**Meeting Name:** Town Council Meeting

**Meeting Date:** August 28, 2024

**Item Title:** Application for a Major Development and Site Plan Amendment to the 700 Ocean Drive Planned Unit Development

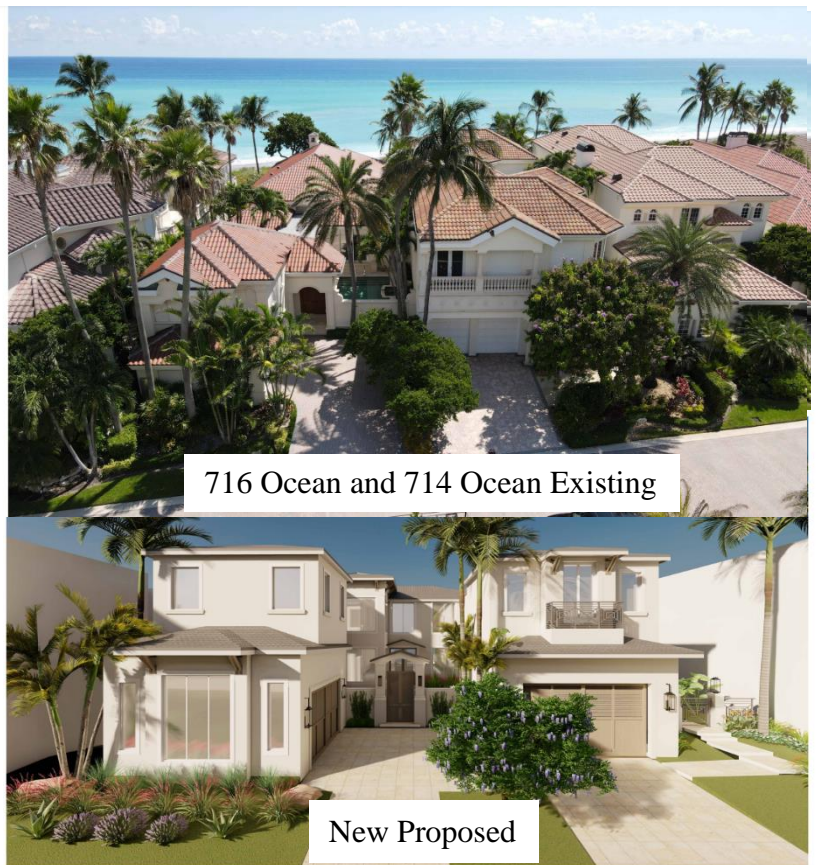
The elevations consist of some Florida Vernacular design elements such as the large lantern lights, large patio spaces, balconies, lush landscaping, and louvered/paneled garage doors just as 704 Ocean Drive did to update the home around 2017. The rear will feature an abundance of glass to capture the ocean view and feeling of outdoor living. Please see picture to the right of 704 Ocean Drive, as the inspiration for the new home.
